Technical Service Bulletin (TSB)

Flash: Powertrain Control Module (PCM) Updates

REFERENCE:	TSB: 18-007-24 GROUP: 18 - Vehicle Performance	Date:	January 25, 2024	REVISION:	18-056-22 REV. A
VEHICLES AFFECTED:	2019 (DD) RAM 3500 Cab Chassis 2019 (DP) RAM 4500/5500 Cab Chassis This bulletin applies to vehicles equipped with a 6.7L I6 Cummins Turbo Diesel Engine (Sales Code ETN).			MARKET APPLICABILITY: ☒ NA ☐ SA ☐ EE ☐ MEA ☐ IAP ☐ CH	
CUSTOMER SYMPTOM:	Customers may experience a Malfunction Indicator Lamp (MIL) illumination. Upon further investigation the technician may find one or more of the following Diagnostic Trouble Codes (DTCs) have been set: • P0506-00 - Idle Control System RPM - Lower Than Expected. • P0607-00 - ECU Internal Performance. • P20E8-00 - Reductant Pressure Too Low. • P0301-00 - Cylinder 1 Misfire. • P0302-00 - Cylinder 2 Misfire. • P0303-00 - Cylinder 3 Misfire. • P0304-00 - Cylinder 4 Misfire. • P0305-00 - Cylinder 5 Misfire. • P0306-00 - Cylinder 6 Misfire. • P0299-00 - Turbocharger Underboost. • P1D73-00 - AGS Performance. • P0626 - Generator Field Control Circuit High. • P218F - Reductant No Flow Detected. • P2002 - Diesel Particulate Filter Efficiency Below

Fig. 1

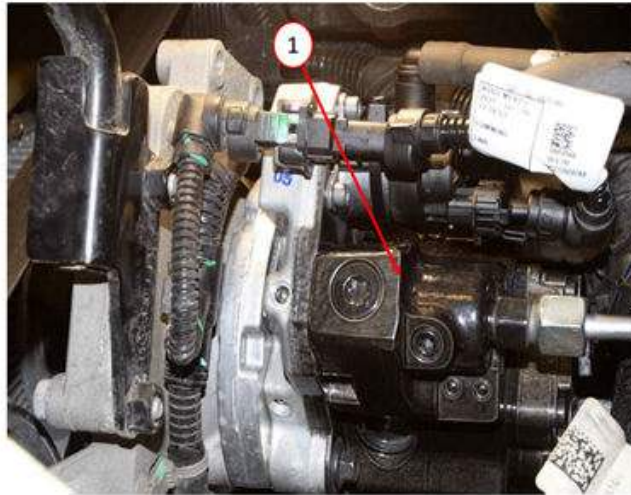
NOTE: The only calibration available will be for the updated CP3.3 design high-pressure fuel injection pump [Fig. 1](#). Please ensure that recall Y78 has been completed first before proceeding with this update.

1. Inspect the high-pressure fuel injection pump [Fig. 1](#) to verify which pump is currently installed on the vehicle. **Also review the vehicle VIP report to see if campaign Y78 has been performed.**

2. Does the VIP report indicate that Y78 has been performed and is the vehicle equipped with the new design fuel injection pump released under the campaign?
 - YES >>> Proceed to [Step 3](#).
 - NO >>> **Perform the Y78 campaign first.** Once the campaign is performed, new pump installed and PCM updated, the PCM will have all of the updates listed in this document. **This Bulletin does not apply.**
3. Reprogram the PCM/ECM with the latest software. Detailed instructions for flashing control modules using the wiTECH Diagnostic Application are available by selecting the application's "HELP" tab.
4. Clear any DTCs that may have been set in any modules due to reprogramming. The wiTECH application will automatically present all DTCs after the flash and allow them to be cleared.
5. Using wiTECH, perform the "Oil Life Restore" procedure located in the ECM "Misc Functions".
